**Flood Control Project Maintenance  
Levee Inspections**  
**LMA District Cover Sheet**  
**Spring 2017 Levee Inspection Results**

**Solano County Public Works Mellin Levee**

**Levee Inspection Report By Mile - Spring 2017**

Photo 2 of 3 : SP\_2017\_NA0012\_258\_12\_20170314\_00008.jpg

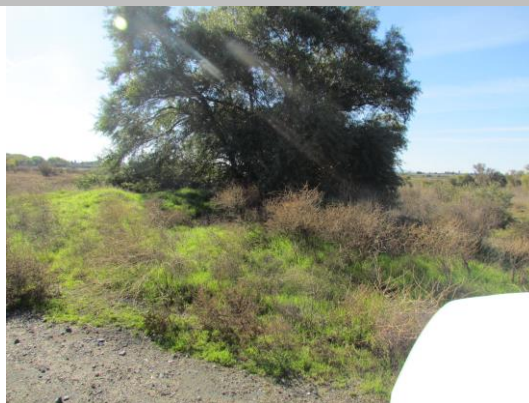
LM Start	0.59	Rating **	M	Issue No.	12
LM End	0.59	Issue Type +	Ma	Location *	LS
Category	Earthen Levee			GPS Latitude/Longitude	
				Start	End
Item	Trim / Thin Trees			38.180062 °	38.180062 °
				-121.681993 °	-121.681993 °
DWR ID	DWR_NA0012_01_s_2015_12				
Comment Code					
T1 : Trim trees to at least five feet above ground level.					
Inspector Comment					
Untrimmed tree on landward shoulder and slope.

Looking southwest at untrimmed tree on landward slope. (Fall 2016)
